THE RANCH PLAN PLANNED COMMUNITY
PLANNING AREAS 3 AND 4 RUNOFF MANAGEMENT PLAN

**RMV PA-3&4 Local Hydrology Analysis – Land use
Designation and Hillslope Areas**

Subject: Rancho Mission Viejo Planning Area 3 and 4 Local Hydrology Analysis – Land use designation of hillslope areas

Table 3. Proposed Hillslope Land Use for PA-3

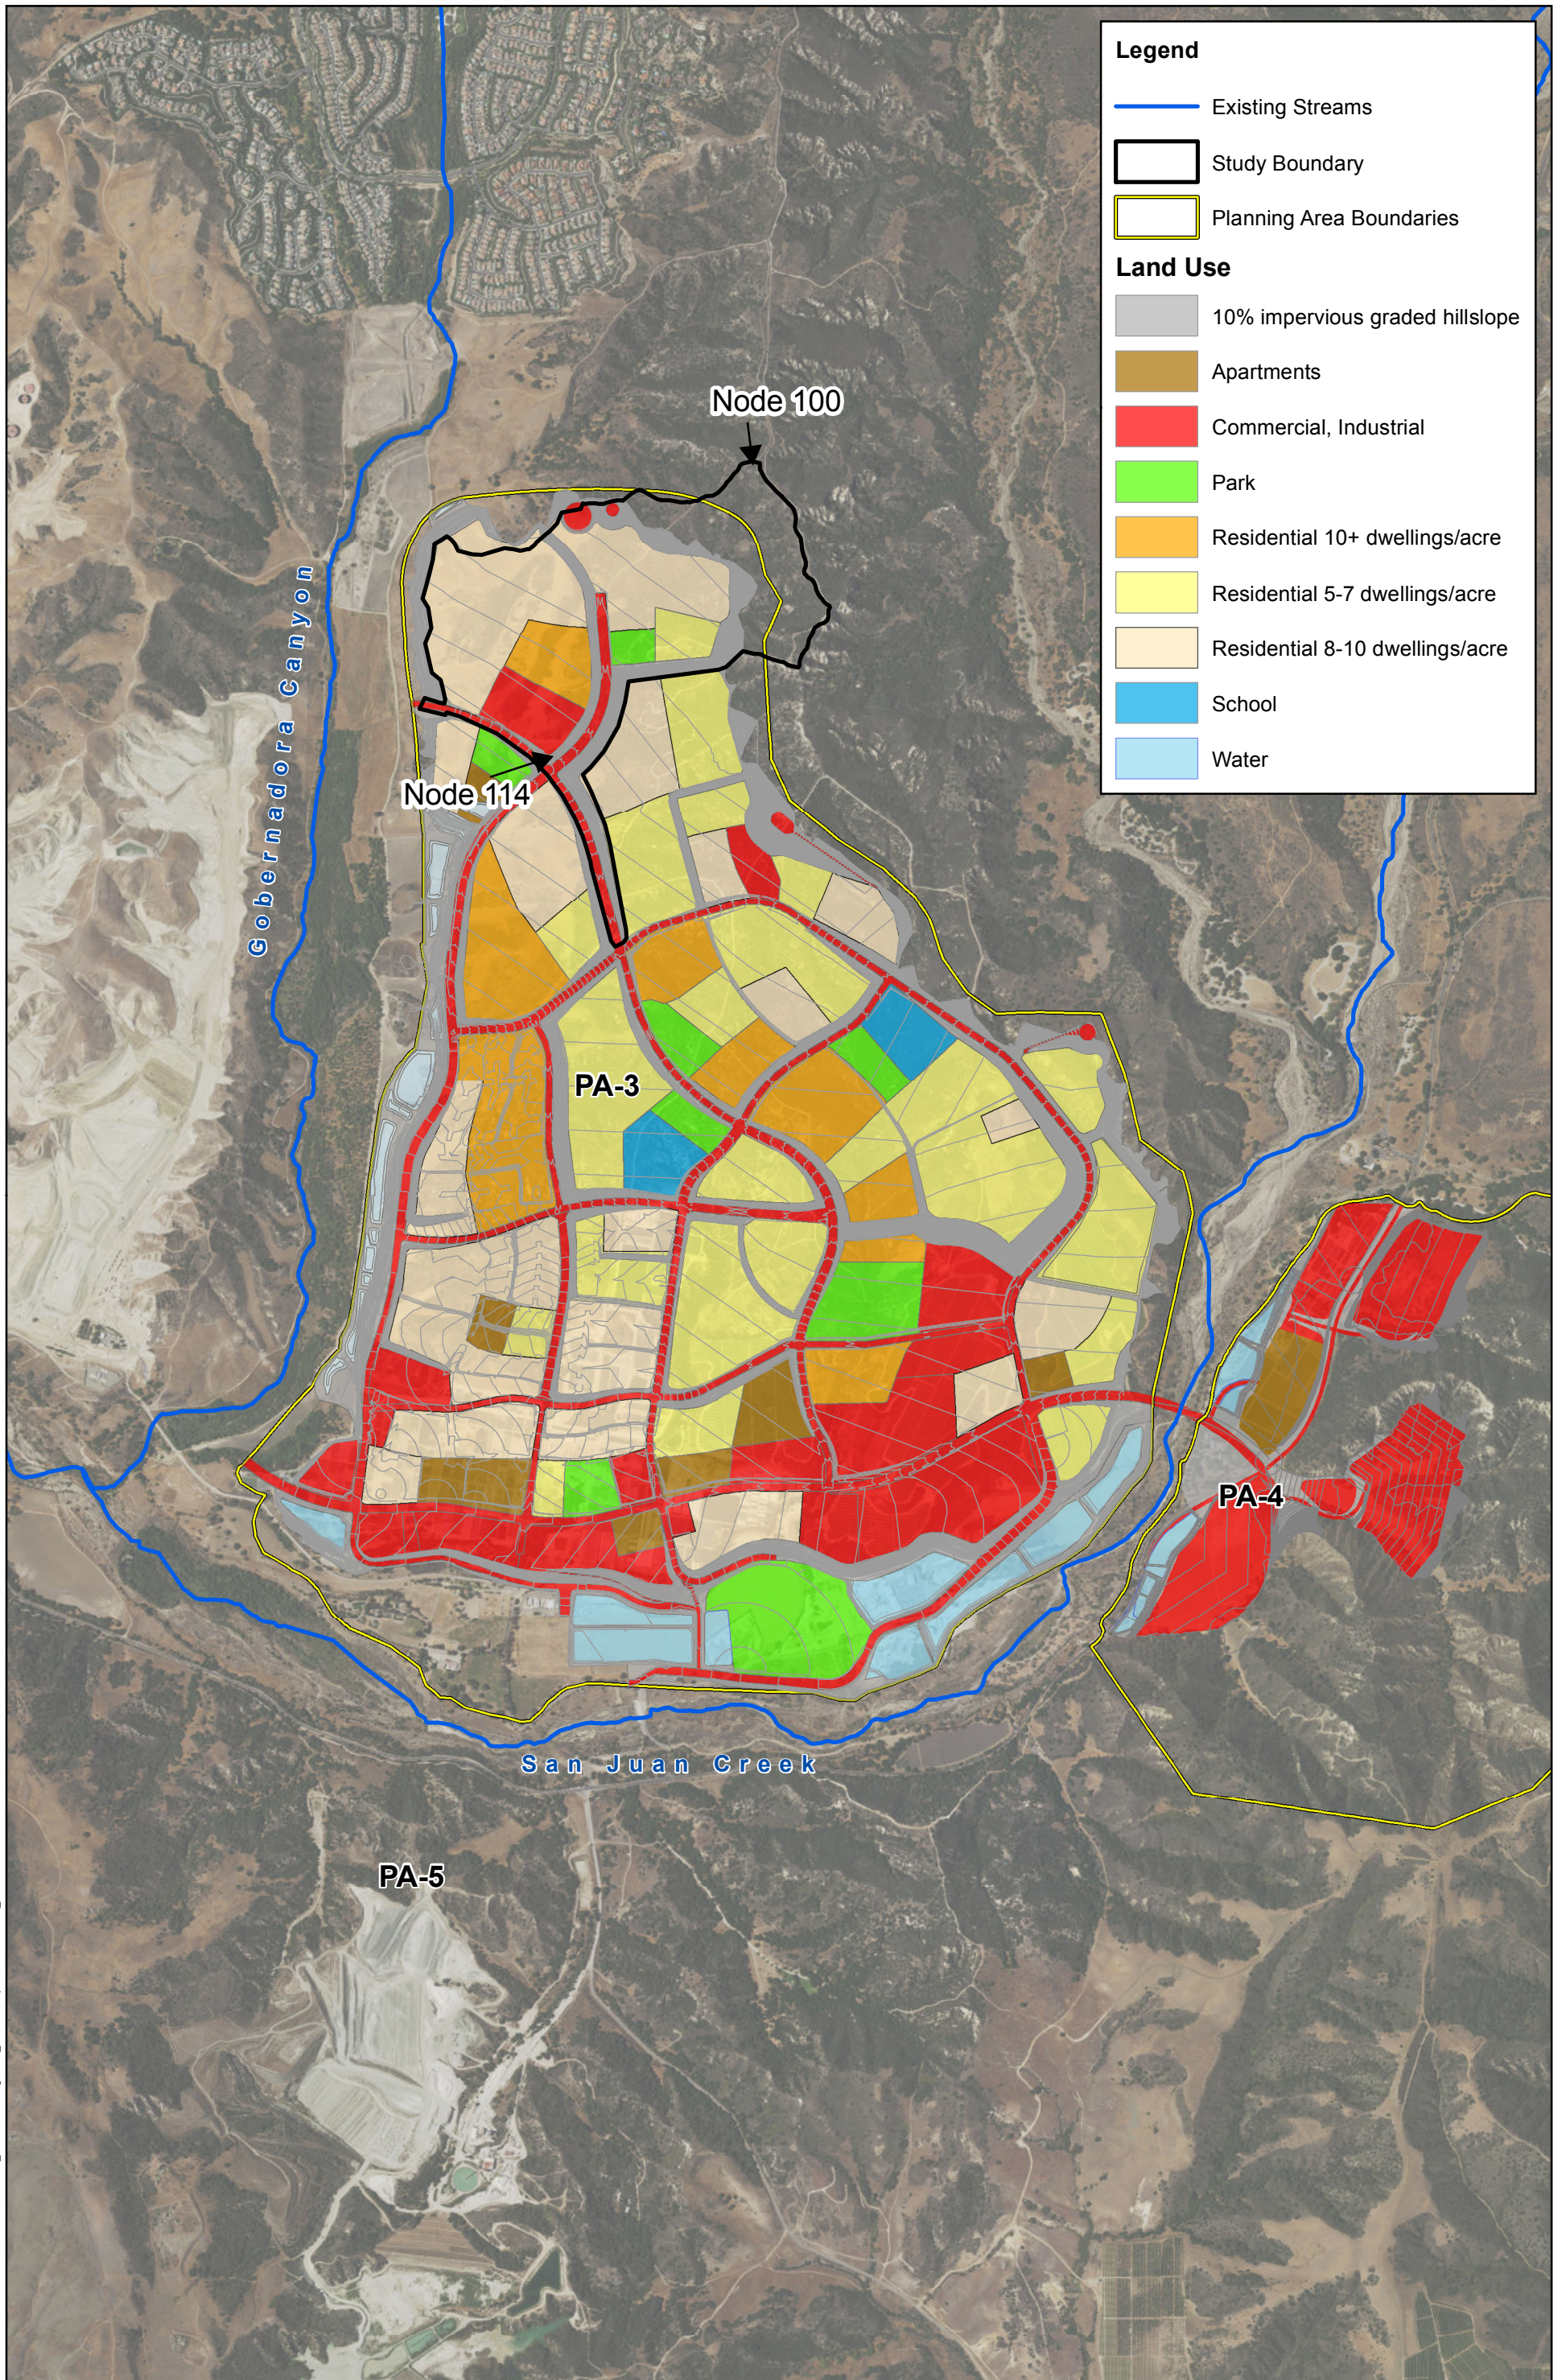
Michael Baker International received the comment response to the January 19, 2017 memo “PA-3 and 4 ROMP Submittal 1 Review Meeting – Follow Up Recommendations.” Reviewer comments on the memo recommended that the PA-3 and 4 ROMP follow the approach used in the PA-2 ROMP by changing hillslope land use from an “open brush fair” designation to that of the adjacent pads. The hillslope areas were originally designated “open brush fair” because that cover type has higher curve numbers than the “residential or commercial landscaping” cover, resulting in higher runoff. While the actual cover may look more similar to the residential or commercial landscaping, the steeper slopes would result in a higher runoff than a typical urban landscape area. Table 1 shows the curve numbers for open brush and residential/commercial landscaping.

Due to the significant increase in volume produced by the change from open brush designation to the land use of the adjacent pad, Michael Baker does not recommend the adjacent land use method. The adjacent land use, adjusted impervious model is not recommended because it does not accurately represent the imperviousness of the tract developments, which could lead to undersized on-tract storm drain facilities in the future design. Michael Baker proposes utilizing a 10% impervious land use for graded hillslope areas. The 10% impervious land use is consistent with the approach used by Hunsaker & Associates for the PA-2 detailed hydrology study for Cow Camp Road. In addition, slopes greater than 60-ft wide (30-ft high) are required to include a concrete terrace drain for drainage,

which is accounted for in the 10% imperviousness. Proposed land uses have been updated and are shown on the attached exhibit. Proposed criteria for hillslope land within the PA-3 planning area boundary use are summarized below:

Criteria	Hydrologic Land Use	Area (ac)
Slopes outside of grading boundary	Existing condition land use	201.9
Slopes greater than 60-ft wide (30-ft high), and slopes tapering down from 60-ft wide	10% impervious (0.4 DU/ac)	320.4
Slopes less than 60-ft wide (30-ft high) at all points	Land use of adjacent pad	18.3
